POLLUTION CONTROL HEARINGS BOARD  
FOR THE STATE OF WASHINGTON

DECLARATION OF WILLIAM A.  
ROZEBOOM IN SUPPORT OF ACC'S  
MOTION FOR STAY

(Section 401 Certification No.  
1996-4-02325 and CZMA  
concurrency statement, issued August  
10, 2001, Related to Construction of a  
Third Runway and related projects at  
Seattle Tacoma International Airport)

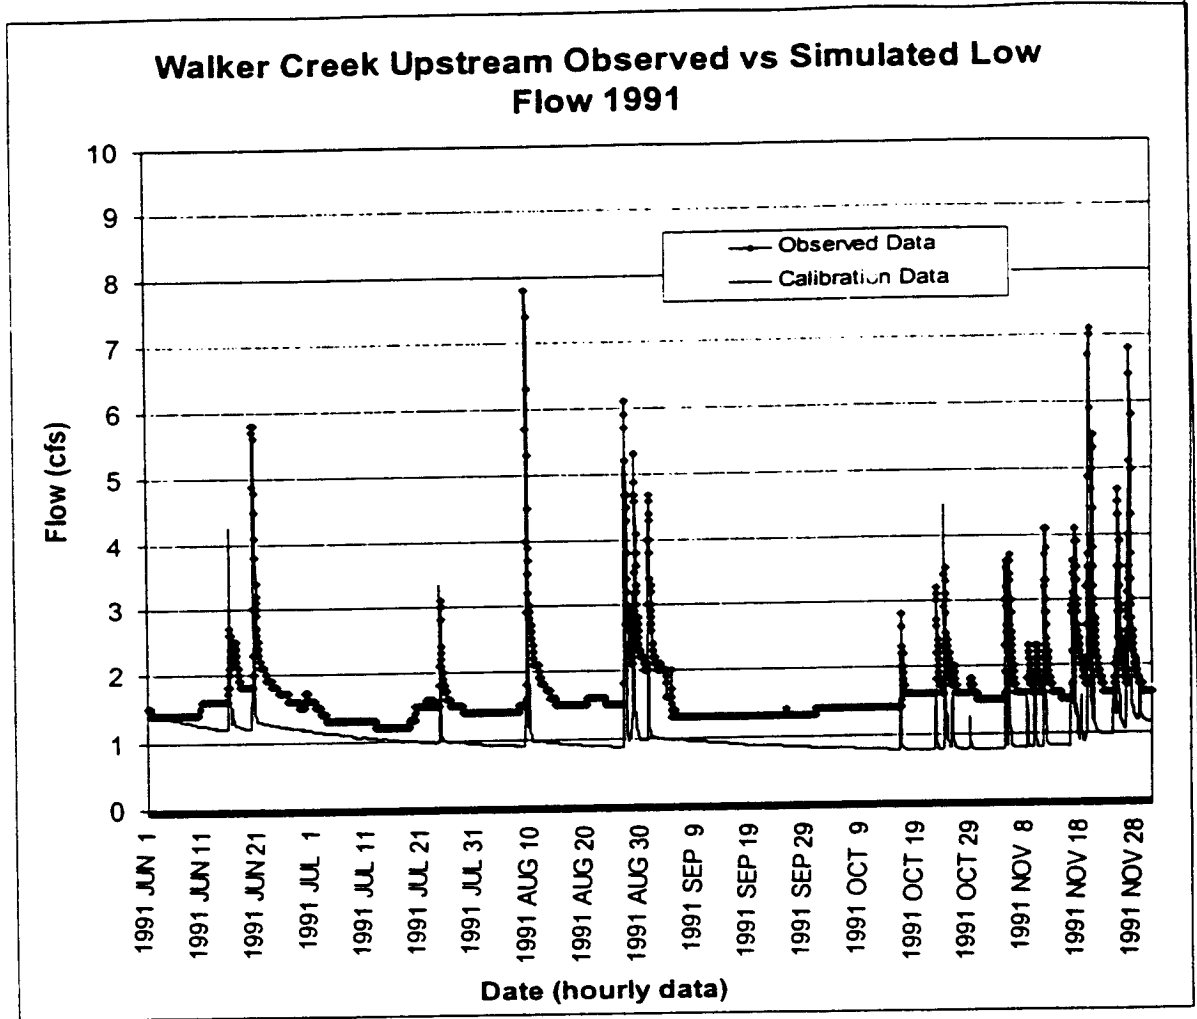
13 July in half of the years with recorded data. The consequence of using a poorly calibrated model  
14 in this situation is that the low flow analysis fails to recognize the low flows which occur in June  
15 and July and fails to provide any mitigation for impacts to low flows in those months. The figure  
16 below illustrates how the simulated streamflow record fails to adequately represent the low flow  
17 conditions in June and July, with the consequence that low streamflow impacts during those  
18 months will not be mitigated under the Port's current proposal.  
19  
20  
21  
22  
23  
24

10. The comment above demonstrates that the poor model calibration in the Walker Creek basin has resulted in a mitigation plan which fails to provide any mitigation during part of the year when adverse impacts to low streamflows may be occurring. The comment below demonstrates that the model calibration in the Walker Creek basin may furthermore be so poor as to either significantly underestimate the magnitude of low streamflow impact or be incapable of quantifying the actual amount of low streamflow impact caused by airport activities.

Walker Ck Streamflow Analysis Fig B

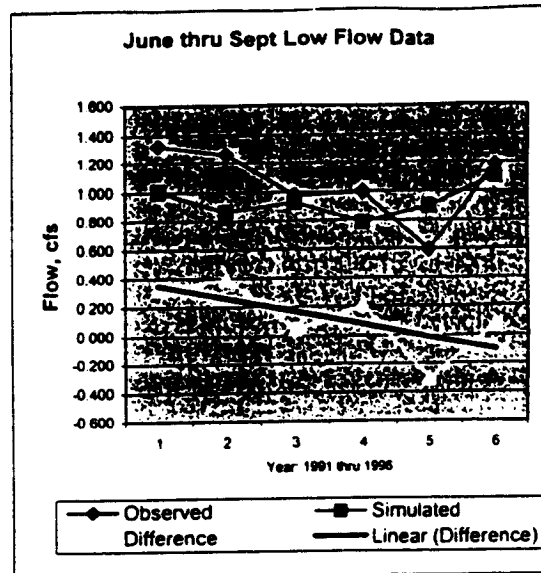
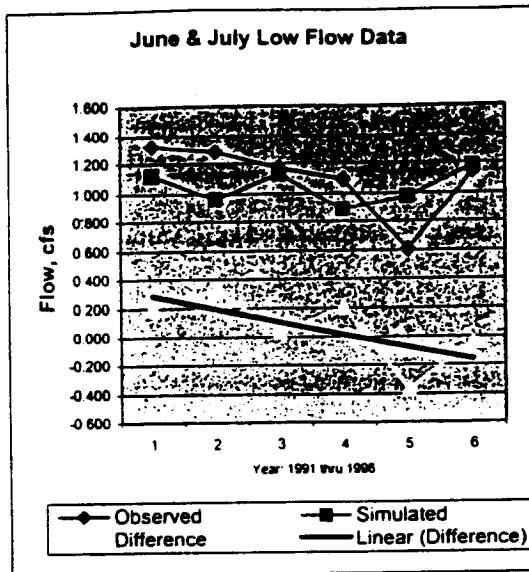
11           12.     The existing conditions Walker Creek hydrologic model serves to simulate  
12 streamflows for the land use conditions which existed in 1994. If the model were perfectly  
13 calibrated to the 1994 condition, then differences between the recorded and simulated data for  
14 other years could indicate changes in basin conditions. We examined the average summer low  
15 flow at the upper basin gage for each year of record, to see if the recorded (actual) flows were  
16 changing relative to the simulated flows. For this evaluation, days with observed and/or  
17 computed flows greater than 1.5 cfs (representing surface runoff) were excluded from the  
18 calculation of average summer low flows. Average value for simulated and recorded low flows  
19 were computed for each year, and plotted as a time series. The results are shown below.  
20  
21  
22  
23  
24

13. We have two alternative interpretations of these results. One interpretation is that there is a pronounced declining trend in the observed data relative to the simulated data for the same period. The analysis shows that summer streamflows are declining independent of climatic variability, and that there has been an average summer low flow reduction of about 0.5 cfs over the period 1991 to 1996. The alternative interpretation is that the Walker Creek HSPF model calibration to low flows, in conjunction with uncertainty as to the quality of observed streamflow data, is too poor to draw any conclusions about anything. Under the first interpretation, the proposed low streamflow mitigation of 0.09 cfs for Walker Creek is probably insufficient to compensate for actual airport impacts which may actually be greater than 0.5 cfs if the data are to be believed. Under the second interpretation, there is substantial uncertainty as to whether the

1 HSPF model is useful for assessing low streamflow impacts or devising a mitigation plan for  
2 Walker Creek. Under either interpretation there is great uncertainty as the adequacy and efficacy  
3 of proposed low flow mitigation measures.
